STAFF ANALYSIS

CASE NO.:	CZ-26-1248015	File ID #: 2026-0444
Address:	2960 North Druid Hills Road, Atlanta 30329	Commission District: 02 Super District: 06
Parcel ID(s):	18 112 01 049	
Request:	Major Modification to amend zoning conditions associated with Case No. CZ-88168 to allow a drive-through facility in the C-1 (Local Commercial)	
Property Owner(s):	Toco Instant Printing Inc	
Applicant/Agent:	Swig c/o Gaskins + LeCraw	
Acreage:	0.44	
Existing Land Use:	Vacant building / former print shop	
Surrounding Properties:	North: TC East: TC South: TC West: TC	
Adjacent Zoning:	North: OI East: R-100 South: MR-1 West: C-1	
Existing Land Use:	Town Center	Consistent Inconsistent - X

STAFF RECOMMENDATION: Denial

CONCEPT SITE PLAN

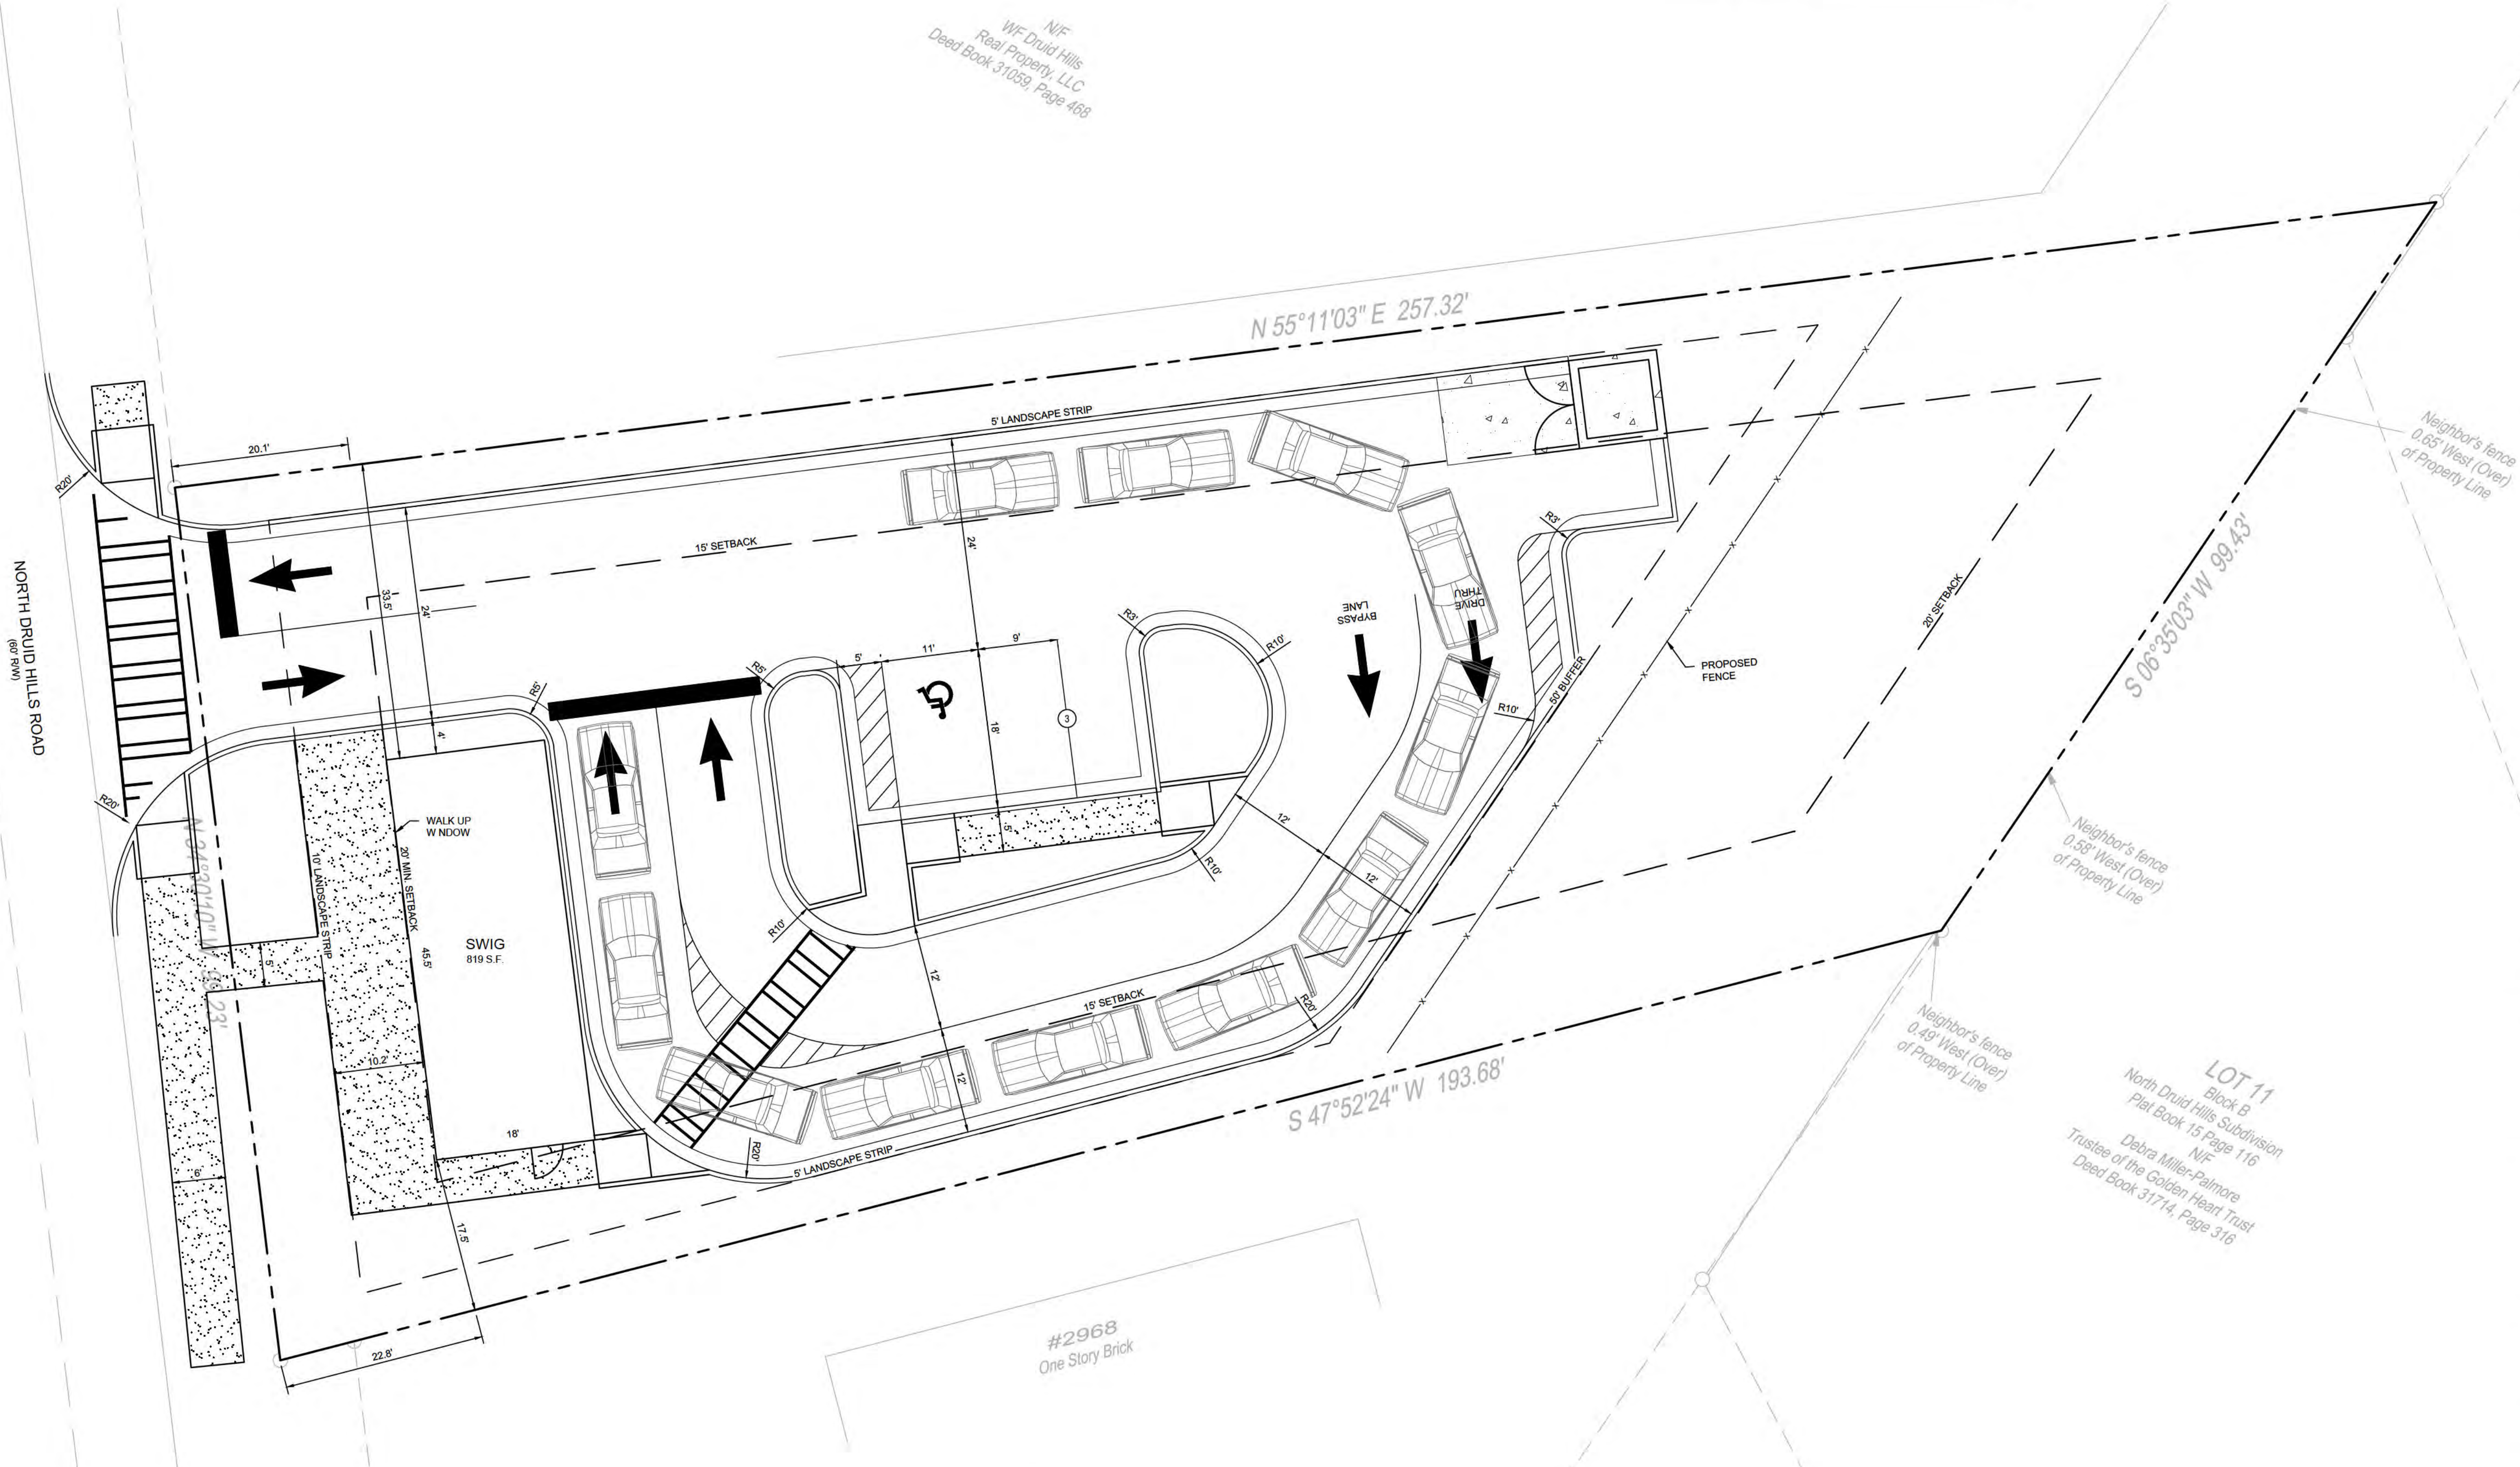
The parcel appears capable of accommodating a small commercial structure, required parking, access, buffering, and screening. The submitted concept plan indicates four parking spaces where a minimum of three are required, continued use of a single access point, and provision of a 50-foot buffer at the rear adjacent to residentially zoned property. Staff's concern, therefore, is not primarily that the site cannot physically accommodate the proposed development. Rather, the concern is that the land use being requested is not the right fit for a Town Center location that is intended to move toward a more pedestrian-supportive development pattern over time.

4. The building shall remain oriented towards North Druid Hills Road, and the drive-through lane and related service functions shall remain to the rear of the building. No drive-through lane shall be located between the principal building and North Druid Hills Road.

5. The walk-up window, front pedestrian waiting area, and bicycle parking shown on the submitted plan shall be installed prior to issuance of a certificate of occupancy and thereafter maintained.

7. A minimum 50-foot rear buffer and an opaque screening fence with a minimum height of eight (8) feet shall be installed and maintained adjacent to residentially zoned or used property.
